JZ24-31 THE GROVE

PRO CONCEPT PLAN

PLANNED REZONING OVERLAY (PRO) PLAN

DATE	7/14/24	SCALE	HOR: 1" = 100' VER: 1" = N/A
DESIGNED BY	SRB	JOB NO.	22149
DRAWN BY	DAB	SHEET	SP-8.1

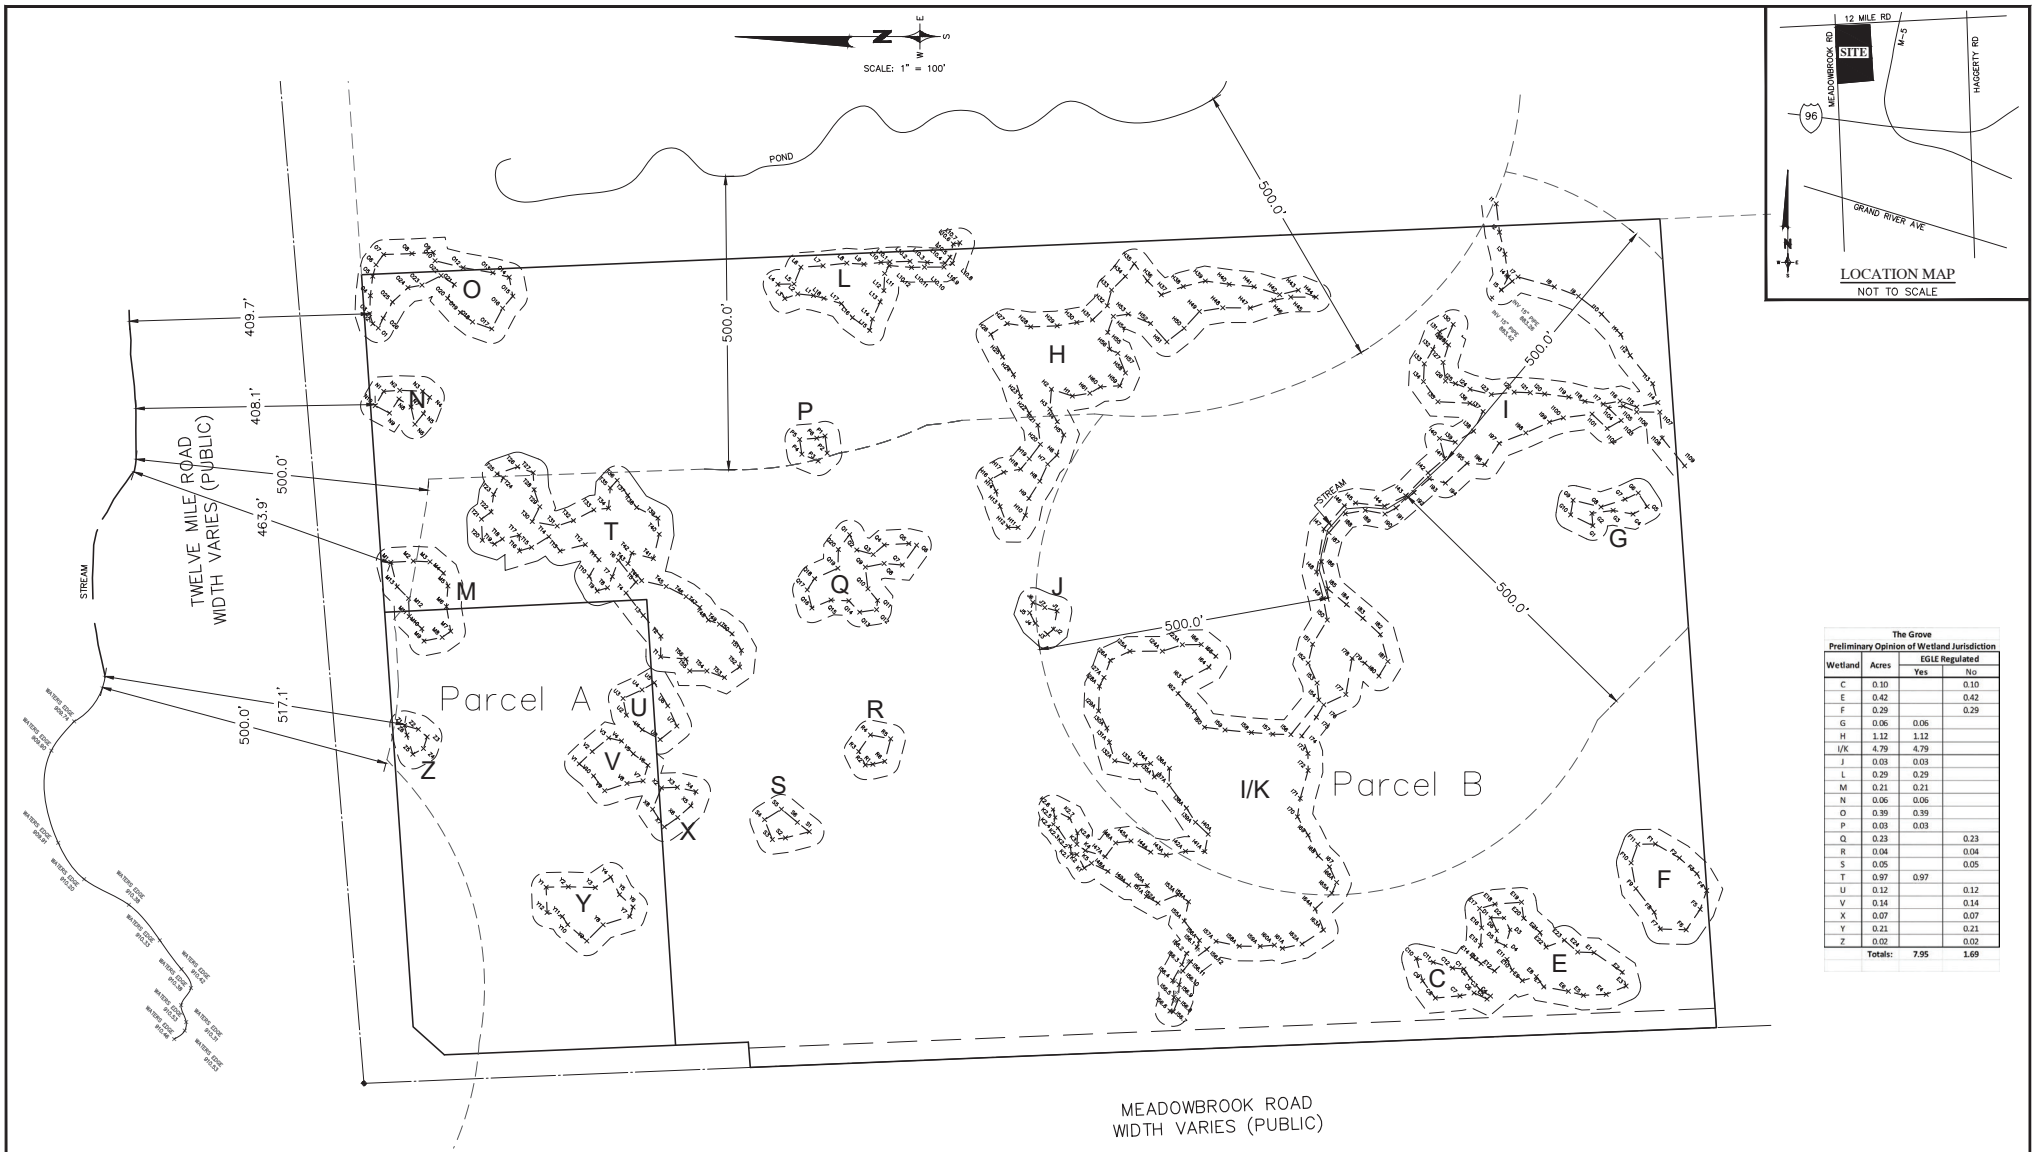
Current wetland classifications in **Table 1** above reflect the classifications noted on Sheet SP-8.1. The total proposed impact to City-regulated wetlands is approximately 1.44 acres.

As noted in your letter, the required wetland mitigation will be provided for all wetland impact. This includes the impacts to wetlands M, U, V, Y, and Z on Parcel A. The wetlands impacts are shown on Sheet SP-8.1. To address the Mergent wetland review comments regarding Parcel A, the undisturbed portion of wetland U on the Grove is a natural area that will remain as a buffer. A portion of wetland X in the Grove will be impacted for the proposed buildings while the balance of the wetland will remain as a buffer.

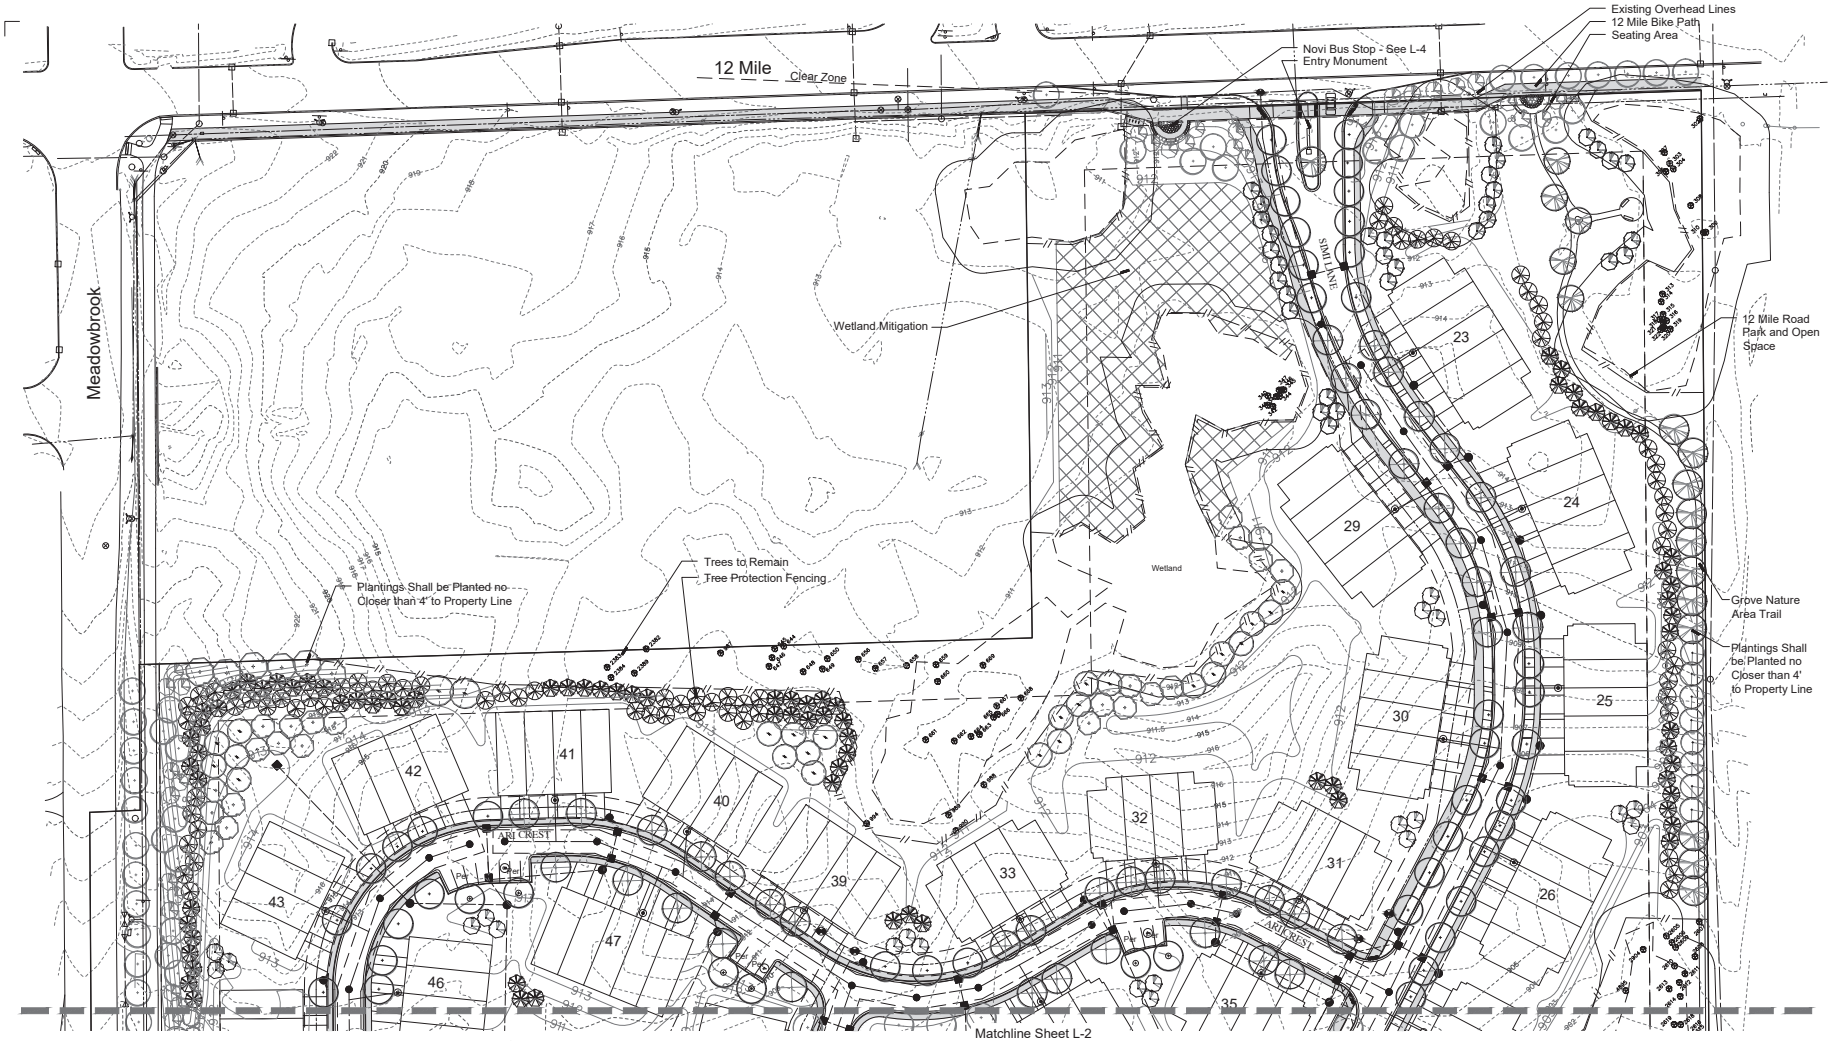
- **Requested edit/clarification:** Sheet L-1 states that 248 trees will be provided on-site and a summary of subsequent sheets states that Sheet L-1 provides 56 trees, Sheet L-2 provides 110 trees, and Sheet L-3 provides 82 trees. Upon further review, Sheet L-2 provides 141 trees and Sheet L-3 provides 112 trees. In further submittals, this discrepancy may be fixed by providing the species, locations, and total number of each species for replacement.

DATE 1/14/24	SCALE HOR: 1" = 100' VER: 1" = N/A
DESIGNED BY SRD	JOB NO. 22149
DRAWN BY DAB	SHEET SP-3

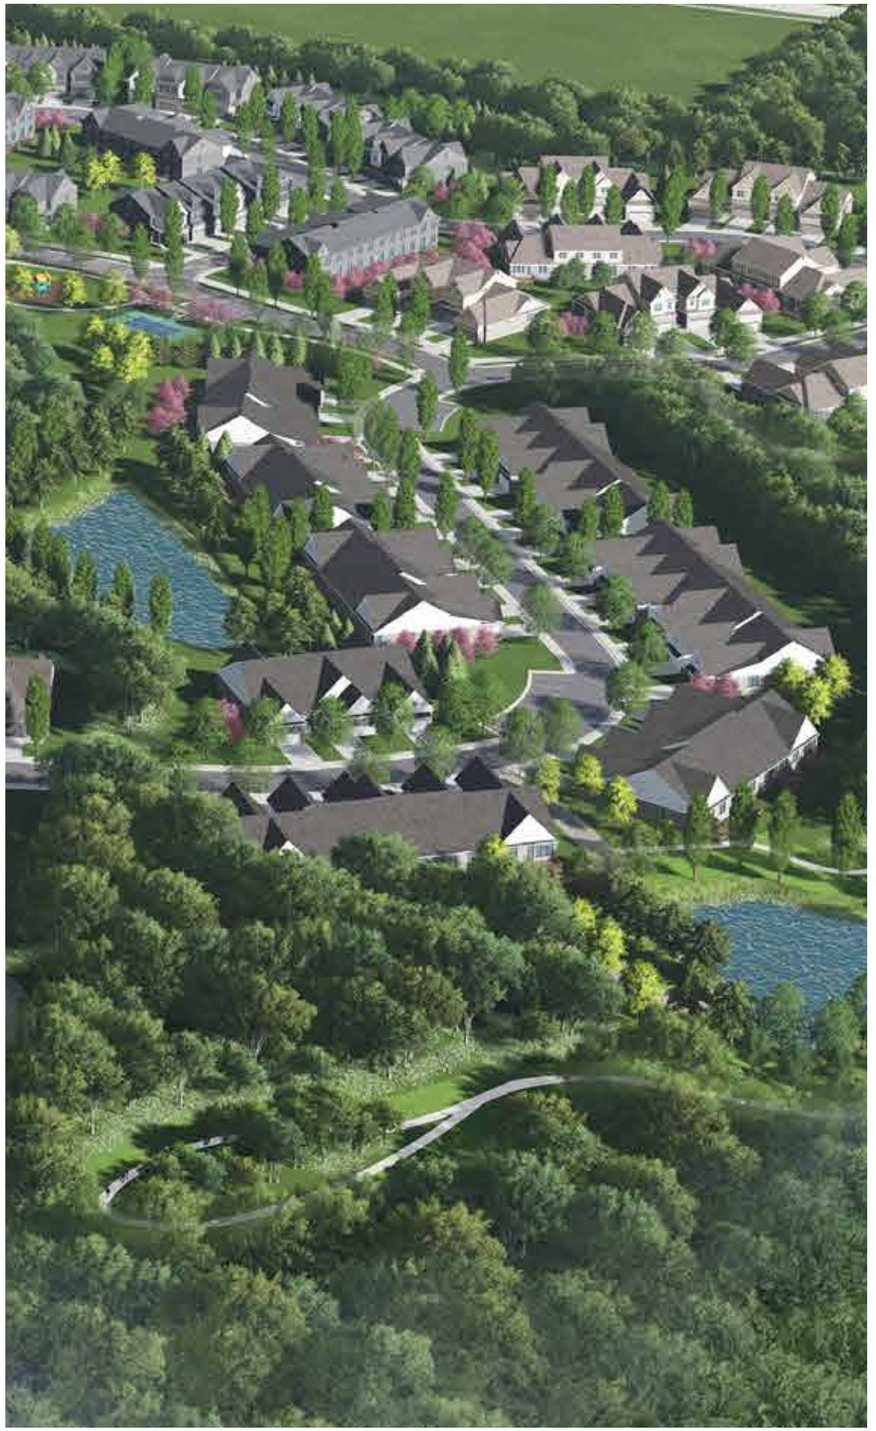
2. Sheet SP-3 indicates that decks and patios may extend a maximum of 10' beyond the building to envelope the perimeter of the building. Show deck and patios for each building to ensure there is no conflict with the detention basin drives, wetland buffers, or the retaining walls.
